TRUCK MEDIUM MC2 (UNIMOG) ALL TYPES
WATER PUMP JOCKEY PULLEY BRACKET

MODIFICATION INSTRUCTION

FIG 1 - BASIC BRACKET WELDING

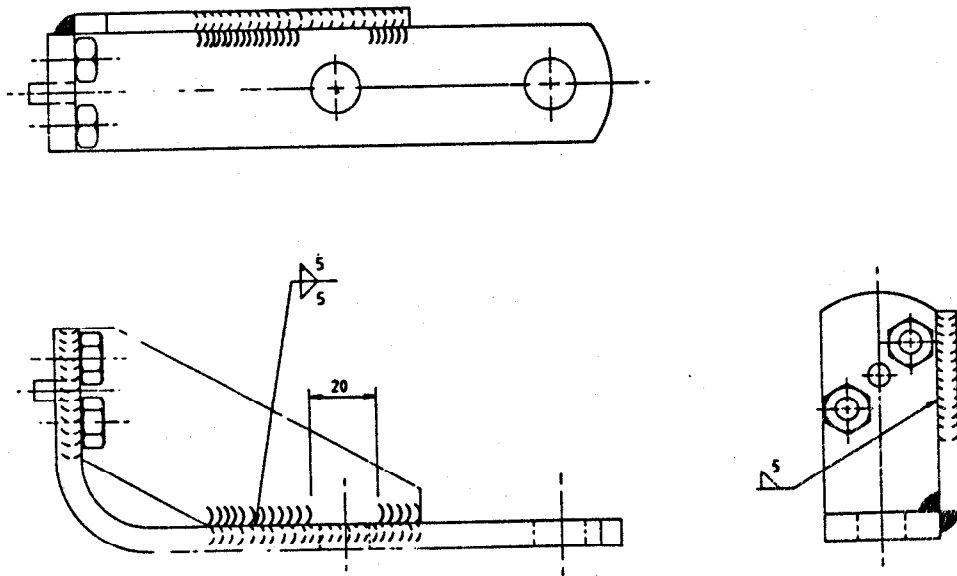
8. Remove the pulley bracket from the engine and proceed as follows:
 - a. Inspect the bracket for cracks and that all welding conforms to Fig 1.
 - b. Weld if required in accordance with WKSP B 010.
 - c. Manufacture a gusset as shown in Fig 2 using item 2, Table 1.
 - d. Fit and weld the gusset to the bracket as shown in Fig 3.
 - e. Paint the bracket in accordance with WKSP B 700.
 - f. Refit the bracket and adjust belt tension in accordance with VEH G 603.

FIG 4 - MODIFIED BRACKET

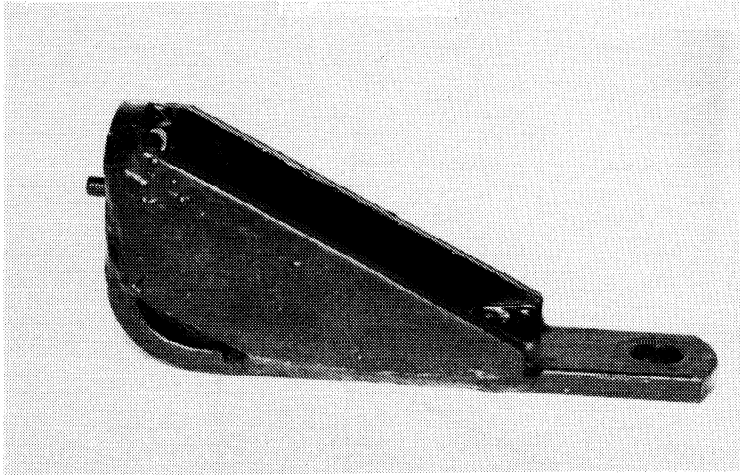
1. Breakage of the subject pulley bracket has continued even after the additional welding detailed in VEH G 617-5. This instruction details the fitting of an additional gusset to the pulley bracket and, combined with the reduced alternator output (VEH G 619-11 refers), should eliminate further breakages.

FIG 5 - ENGINE MODIFICATION PLATE LOCATION

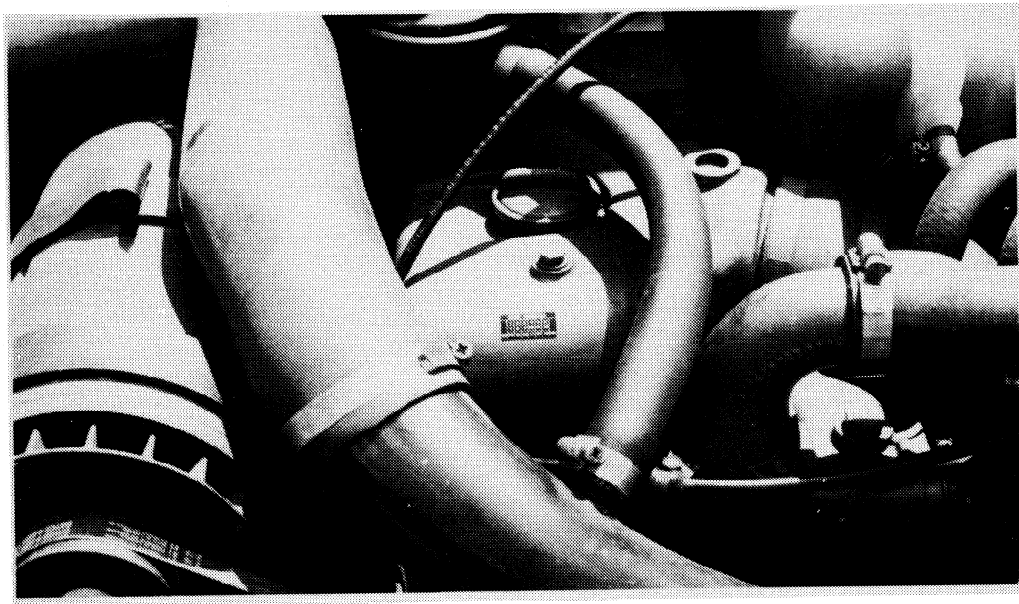
9. Fit the modification record plate (item 3, Table 1) using item 4, Table 1 to the engine as shown in Fig 5 and deface the Numeral 1.
